[Final environmental impact statement: Flambeau Mining Co., copper mine, Ladysmith, Wisconsin]. 1990

Madison, Wisconsin: Department of Natural Resources, Bureau of Environmental Analysis and Review, 1990

ENVIRONMENTAL IMPACT STATEMENT PROCESS

Figure 3-2
Groundwater Drawdown at End of Mining

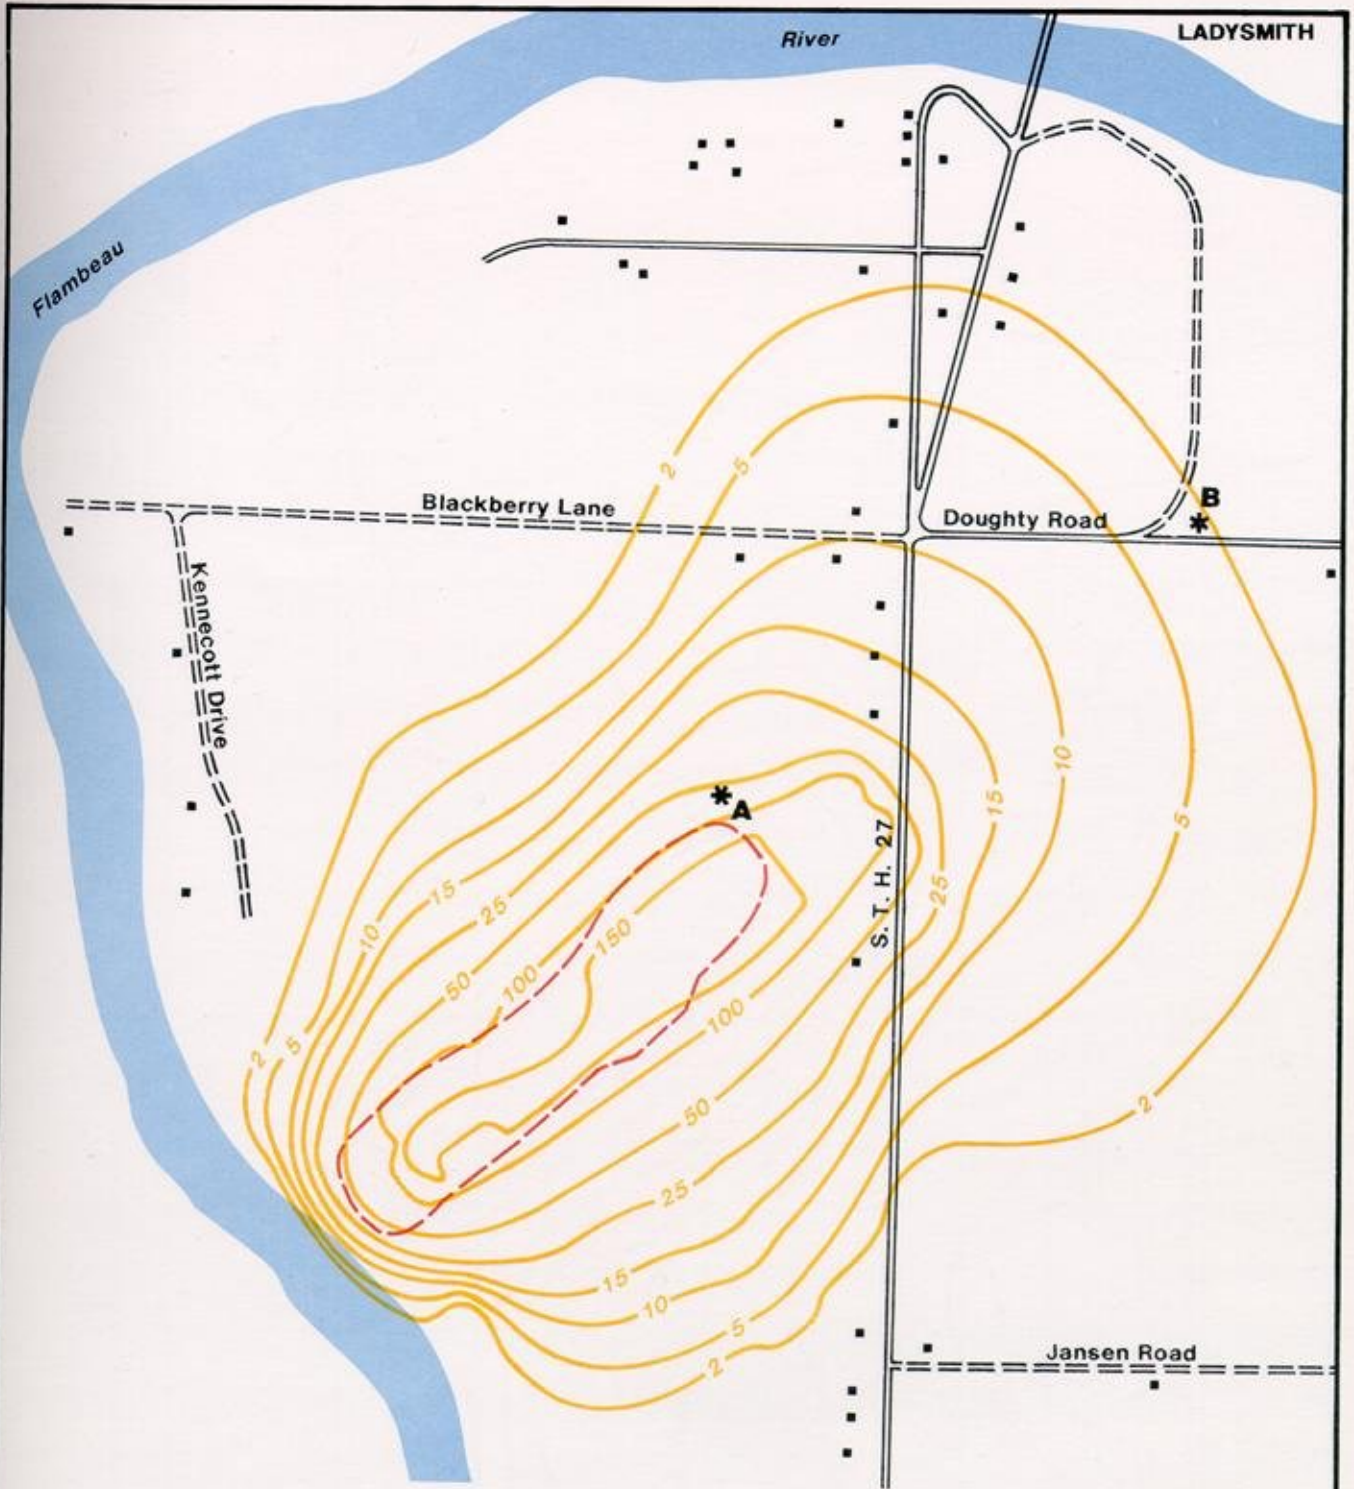
72. Figure 3-2 and figures following. The significance of parts A and B (asterisks) should be noted. [MM]
